SHEET	NONE
HEAT TREAT	
FINISH	
NAME	INSTALL. - FURNS MECHANICS SEAT
CONSOLIDATED AIRCRAFT CORP.	San Diego, Calif.
SIZE	J
DWG NO.	28F5984
SCALE	NONE

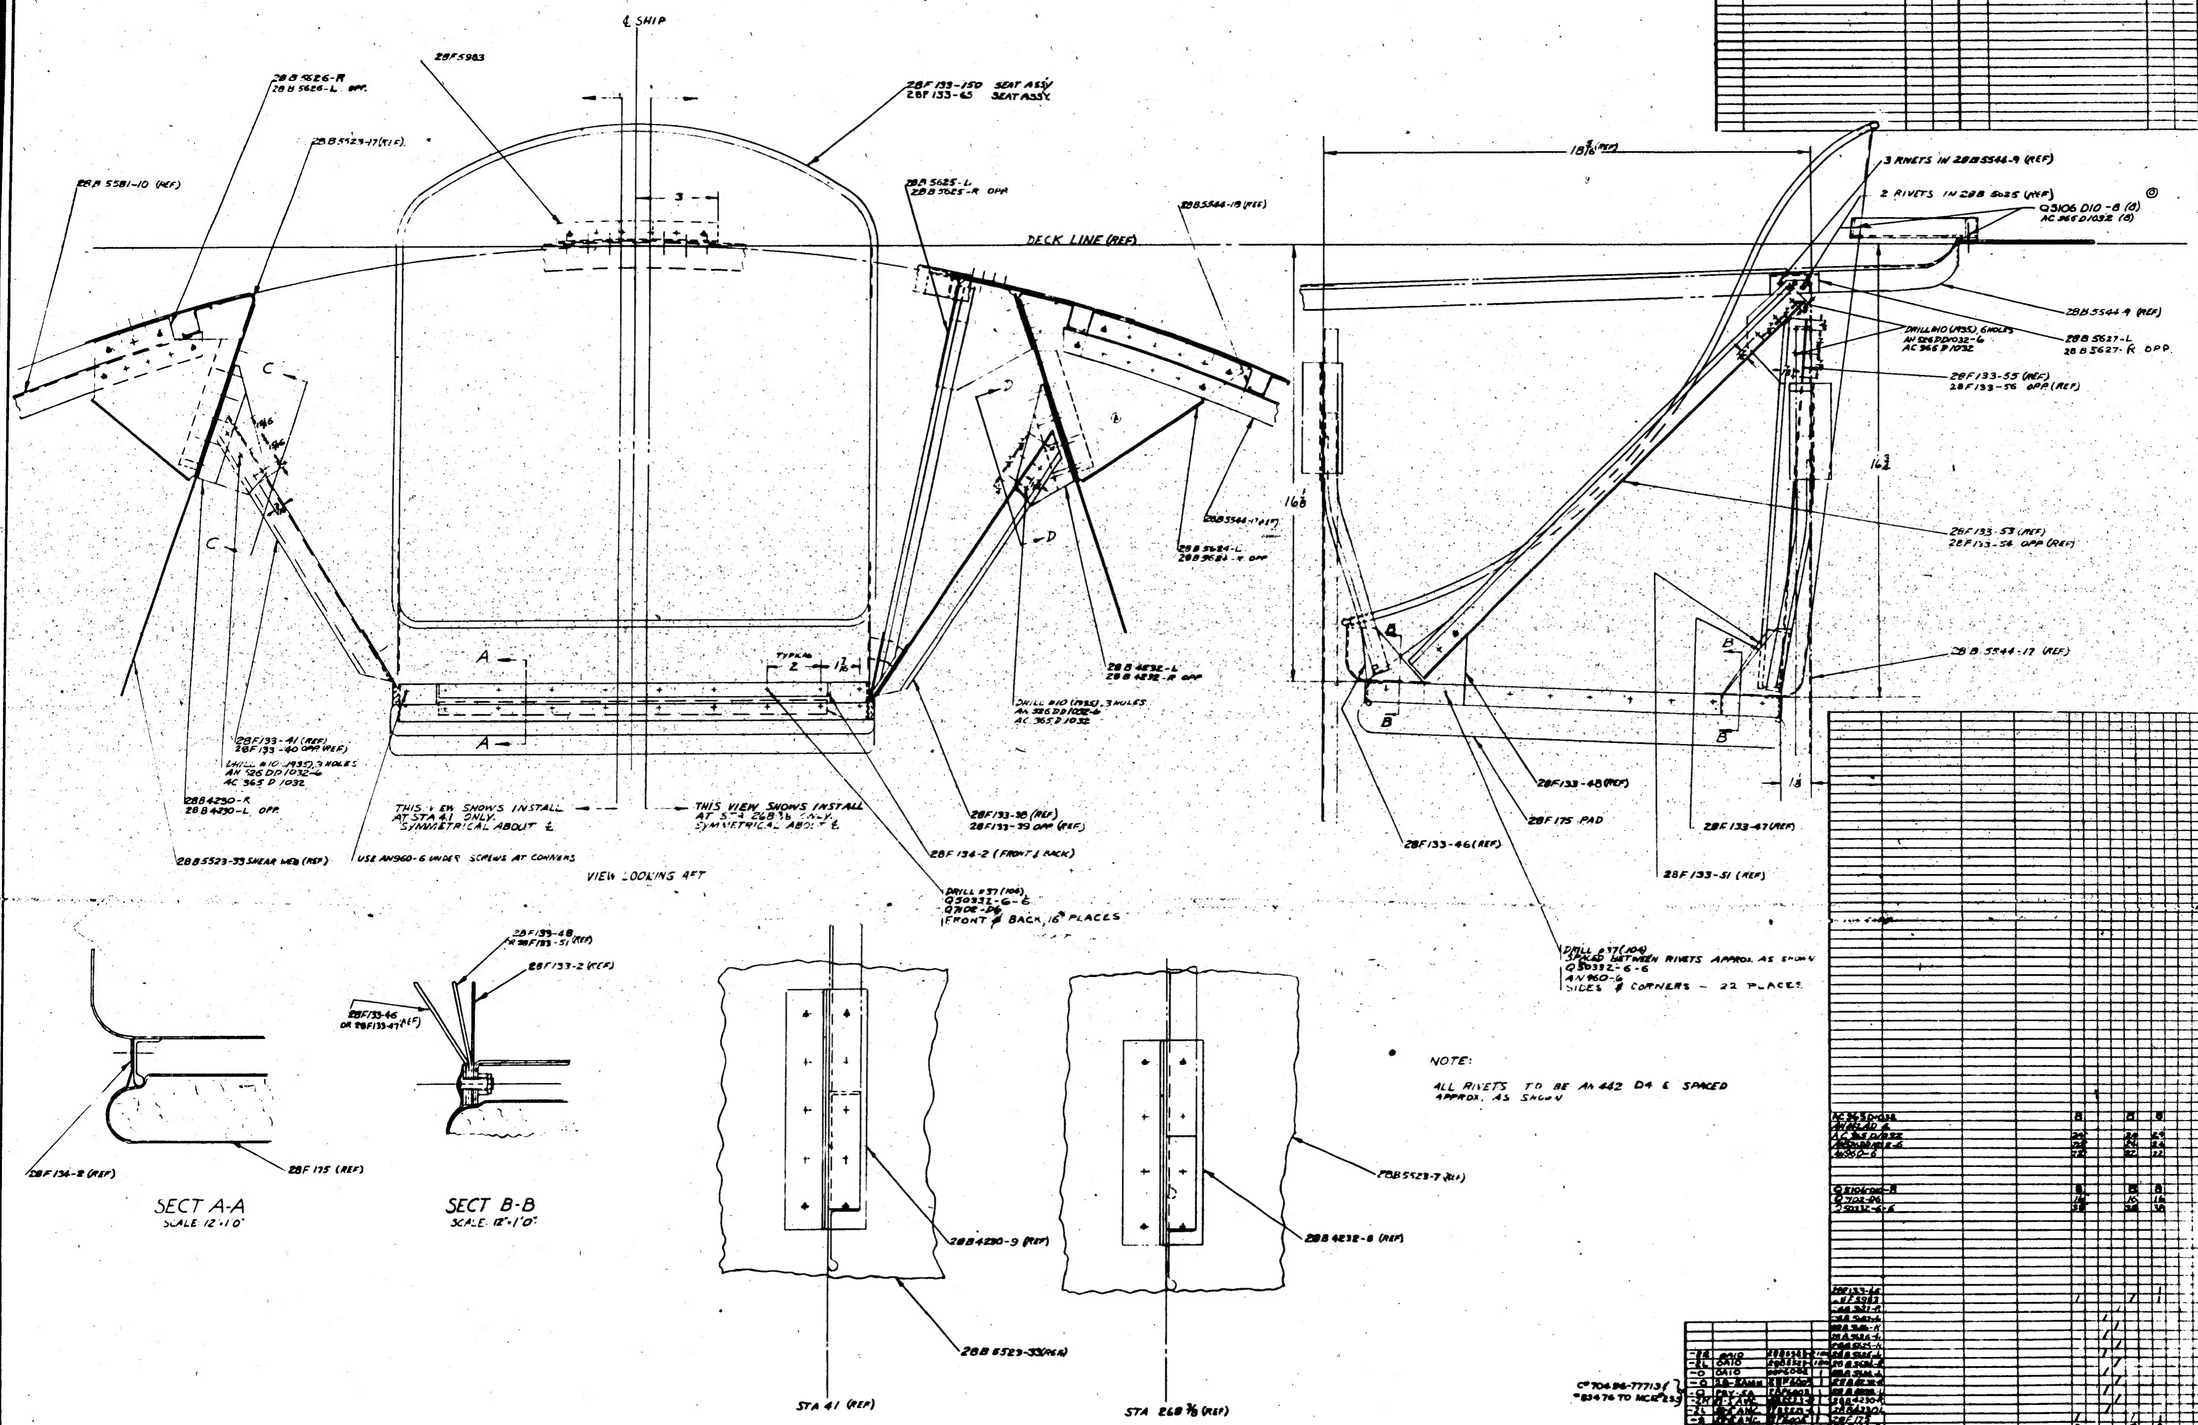
LET	ALTERATION	DATE	BY
A	ON DRAWING ON THIS SHEET ADDED & NOT CALLED FOR ON ASSY SHOWN ON THIS SHEET.		
B	CREATED A ASSY. IDENTICAL TO -0 EXCEPT 28F133-54 & 56 REPLACES 28F133-150 NOT ON ASSY.		
C	QS106-D10-8 (8) & AN442-8 RIVETS (8) WERE AN442D8D4 RIVETS. NOT CHG. MFG.
